Subject: Pre-Application Summary Notes for Holland Scholls Heights (PA2021-0050)

PRE-APPLICATION CONFERENCE MEETING SUMMARY NOTES

Prepared for
Holland Scholls Heights
PA2021-0050, September 1, 2021

Project Name: Scholls Heights Apartments, Holland @ Scholls Heights MF Phase 5

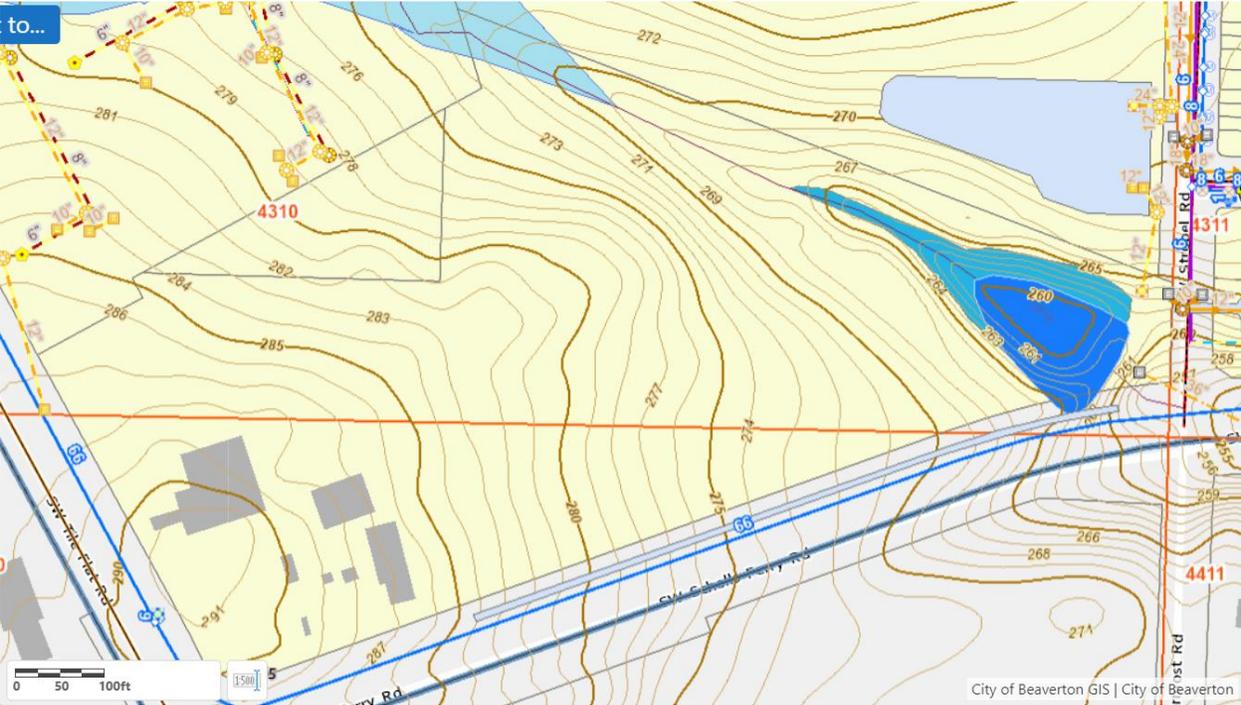
Future City of Beaverton sanitary sewer and storm drainage systems are currently in construction in the vicinity of this project (Scholls Heights Phase 1A development) and should be able to serve this site. There is an 8" sanitary line and a 12" storm line being constructed with this development. Design feasibility to these systems must be shown with the land use application.

City of Beaverton is the water provider for this site. There is a 6" water line being constructed with the Scholls Heights Phase 1A development north of the site. Design feasibility to these systems must be shown with the land use application. The 66" Willamette Water Supply Transmission line is located along Scholls Ferry Rd. and Tile Flat Rd. Verify proposed improvements do not conflict with this line or associated easements. A City Service Provider Letter (SPL) will be required for new connections to the water system, see next page for contact information.
